CLIVE PLANNING & ZONING COMMISSION

RE: Site Plan Amendment - Tenant and Facade Updates - 10001 University Ave

Re: 10001 UNIVERSITY AVE - drive through and parking addition - Site Plan Amendment

SITE PLAN FOR:
10001 UNIVERSITY
CLIVE, IOWA

Sheet Title
EXTERIOR ELEVATIONS

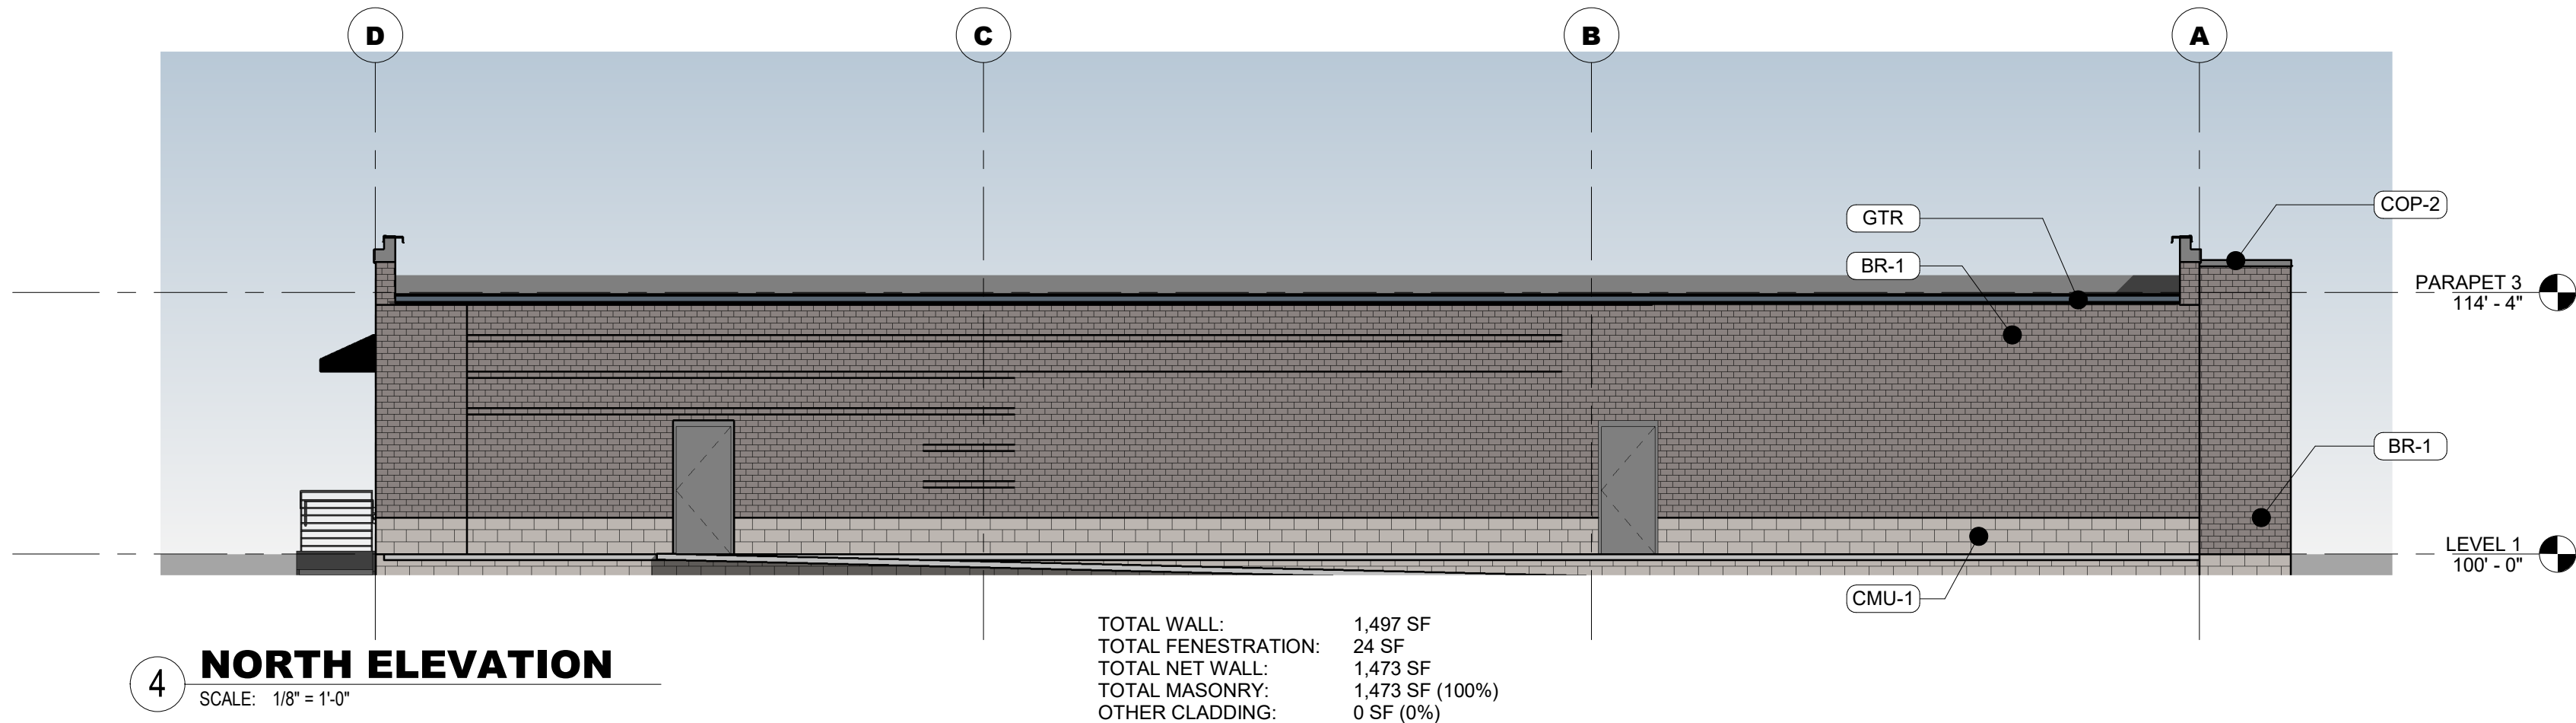
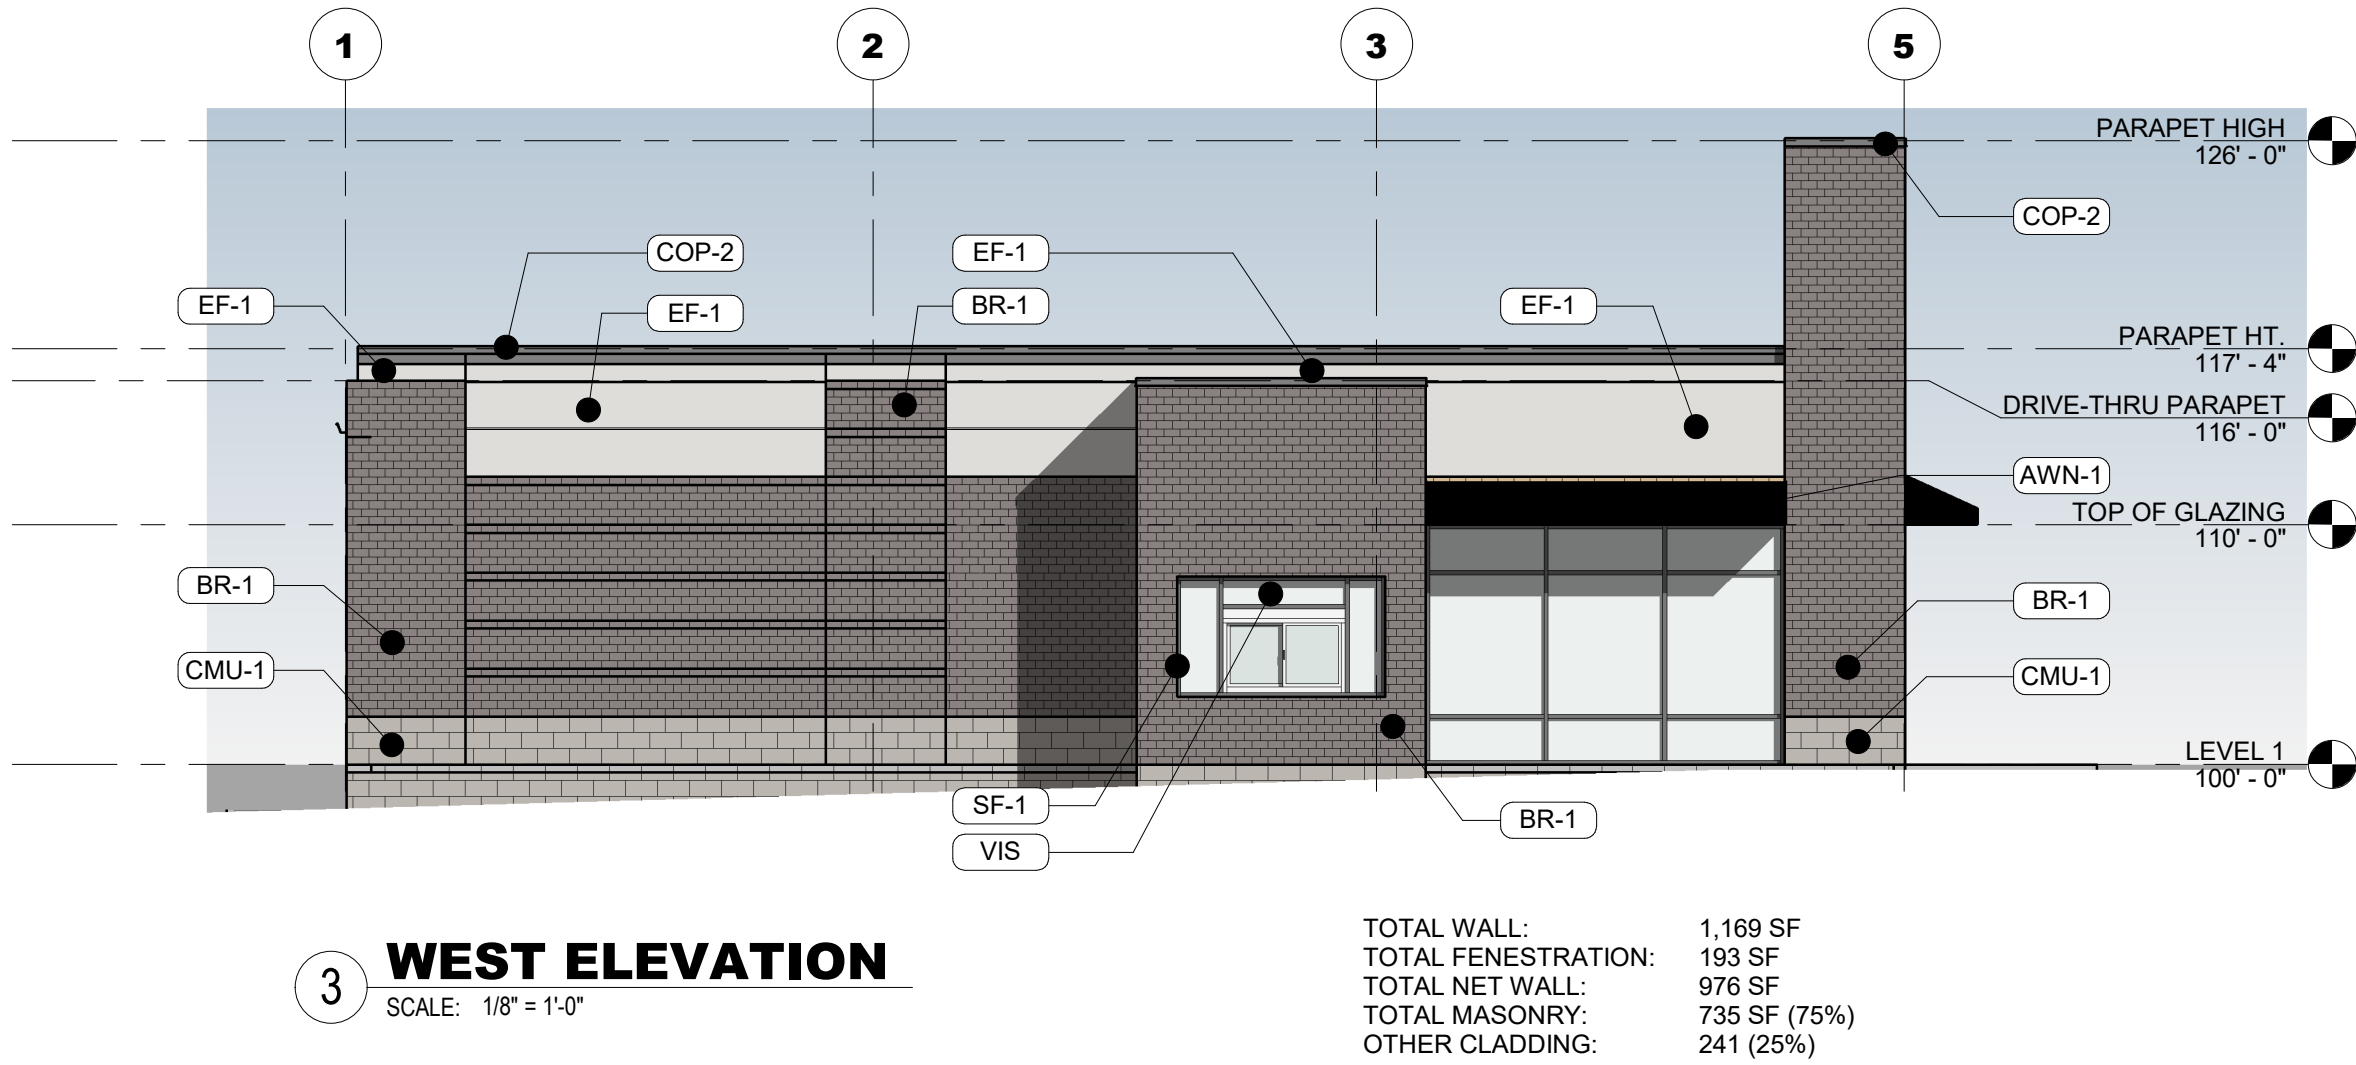
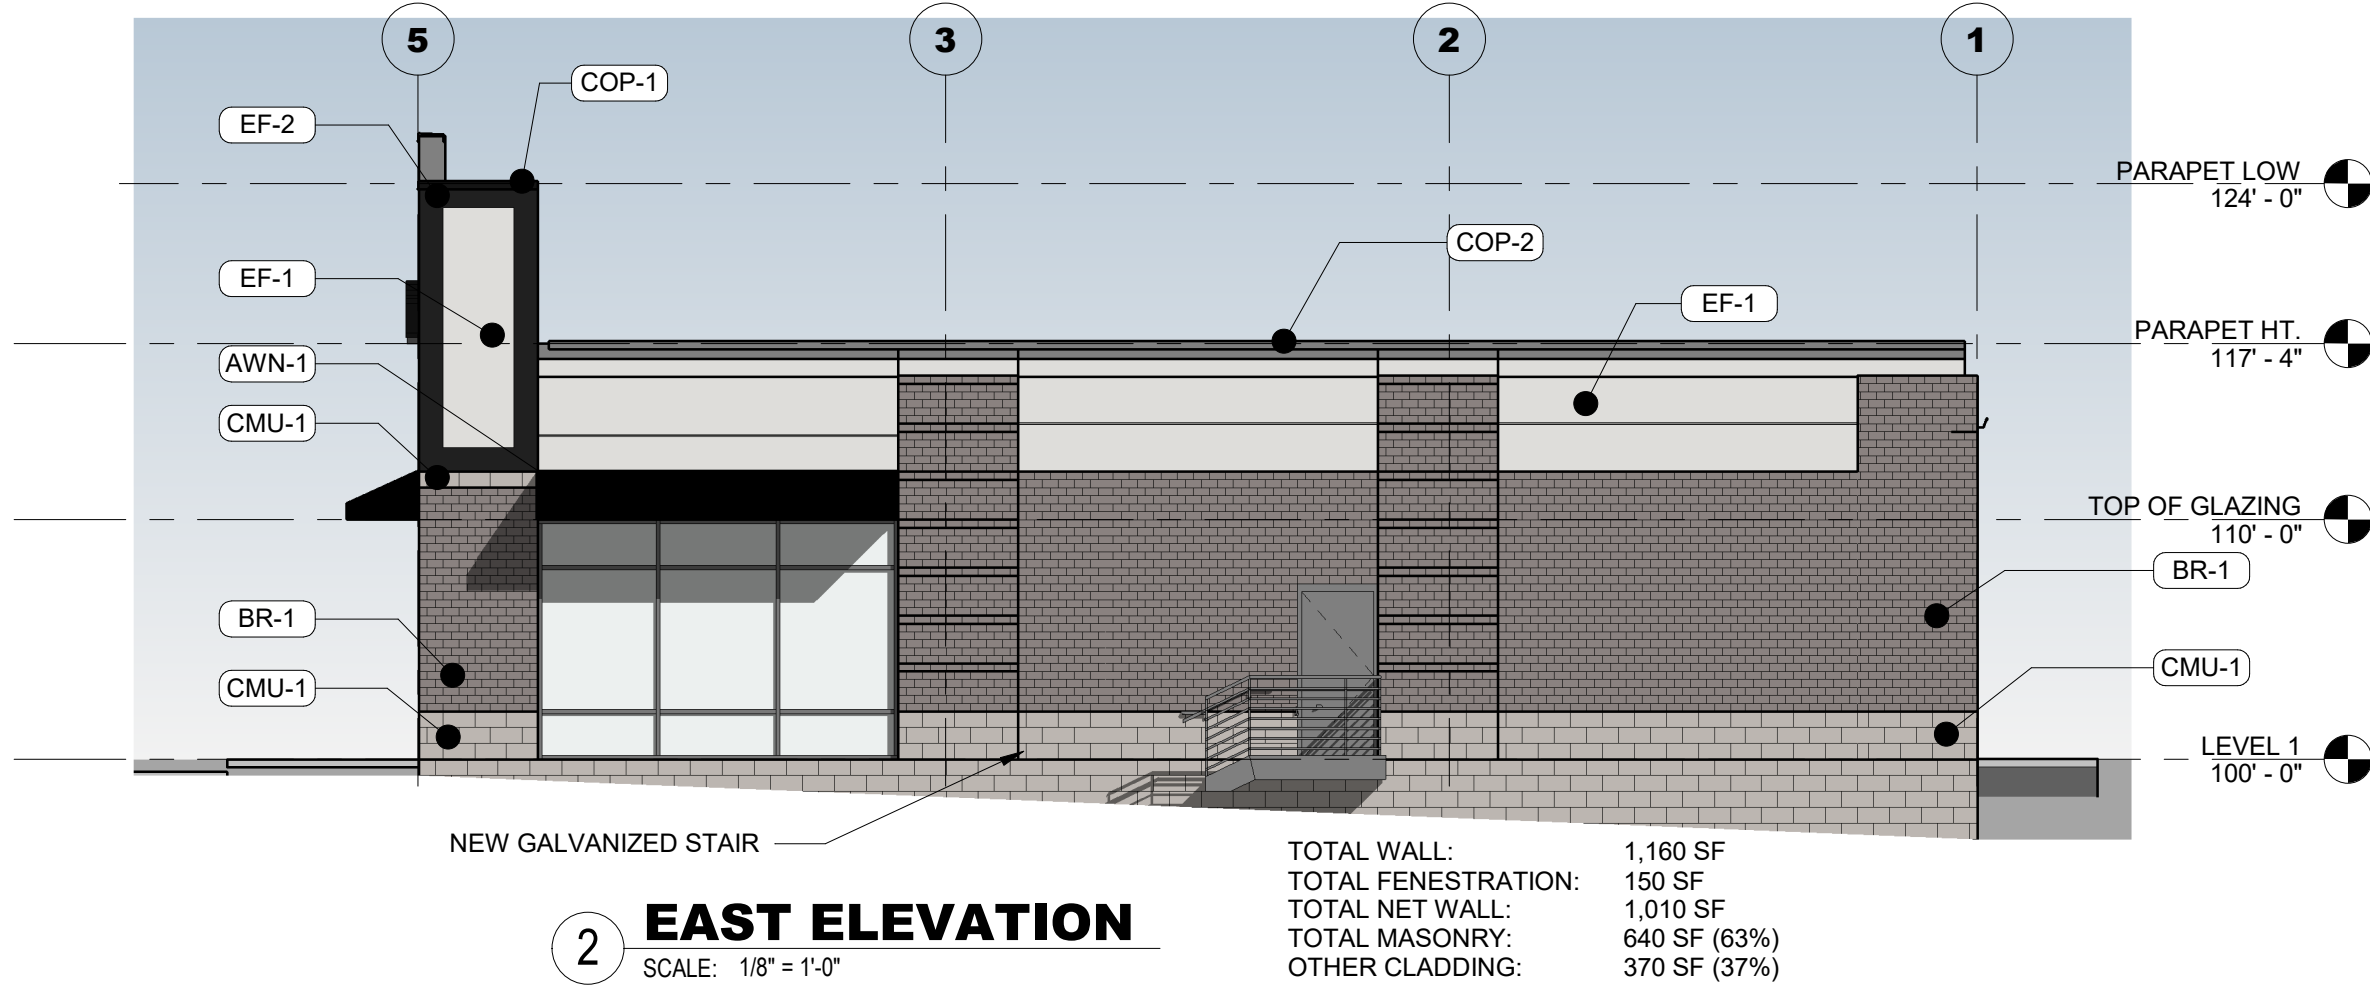
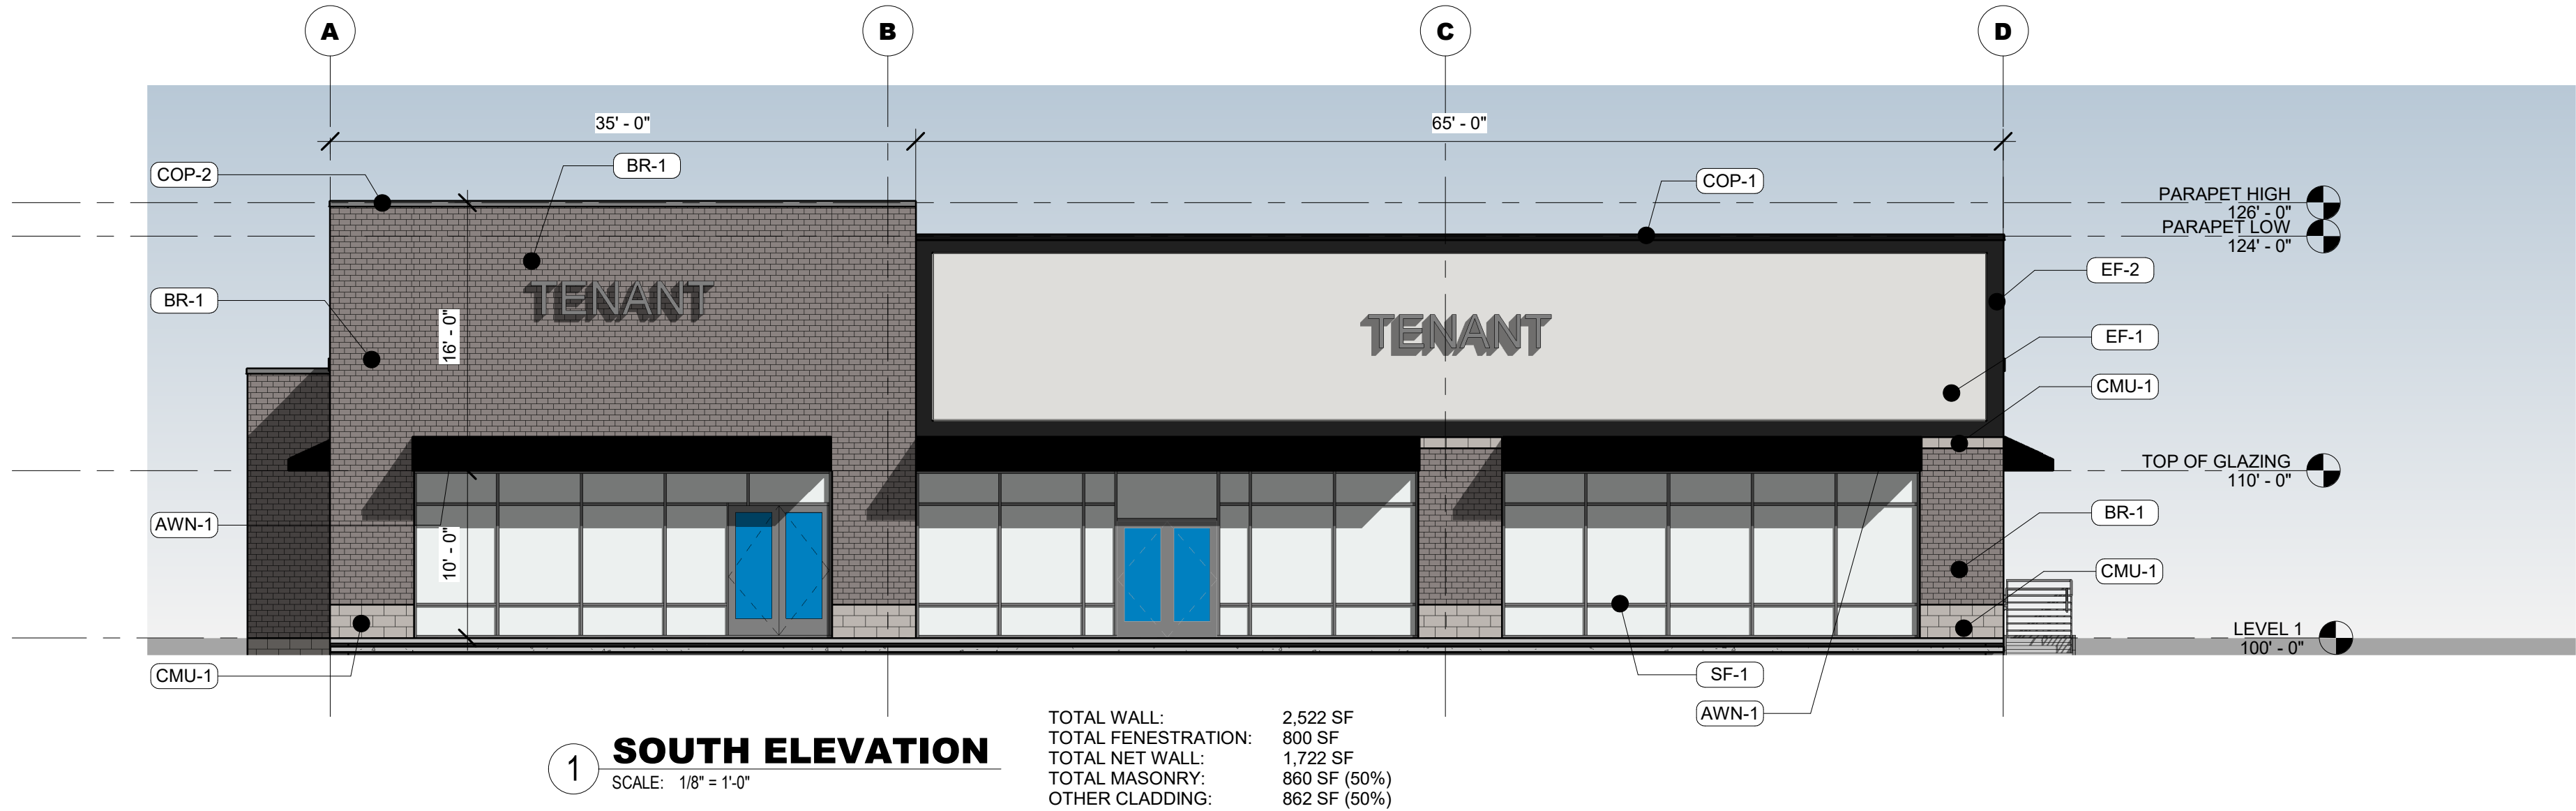
1. Staff appreciates the additional brick added to the south elevation and recognizes the challenge in providing an aesthetically pleasing facade update meeting the 60% masonry requirement across two tenant spaces (as opposed to one or three due to the building dimensions and existing fenestration). Staff believes the intent of the architectural standards are being met and will recommend approval with the deviation of primary materials to 50% on the south facade.

1. Add the dumpster enclosure to the architectural elevations. Specify materials matching the building.
2. Revise the south and east elevations to include a minimum of 60% primary material. EIFS is not a primary material. Refer to the Architectural Standards section of the Clive Development Standards Manual at https://cms9files.revize.com/cliveia/services/community_development/Planning%20Services/Clive%20Development%20Standards%20Manual%20III.pdf.

only 50% brick or masonry. The existing facade does provide 60% brick or masonry. There are currently three large areas of glass storefront which are to be maintained with minor revisions to entry locations. The existing storefront and fenestration proportions lend themselves well to a one or three tenant building, but maintaining 60% masonry across two tenant spaces with the updated parapet design is aesthetically challenging. Staff believes the intent of the Development Standards Manual is being met with the proposed changes and recommends approval with the deviation to 50% brick or masonry on the front/south facade.
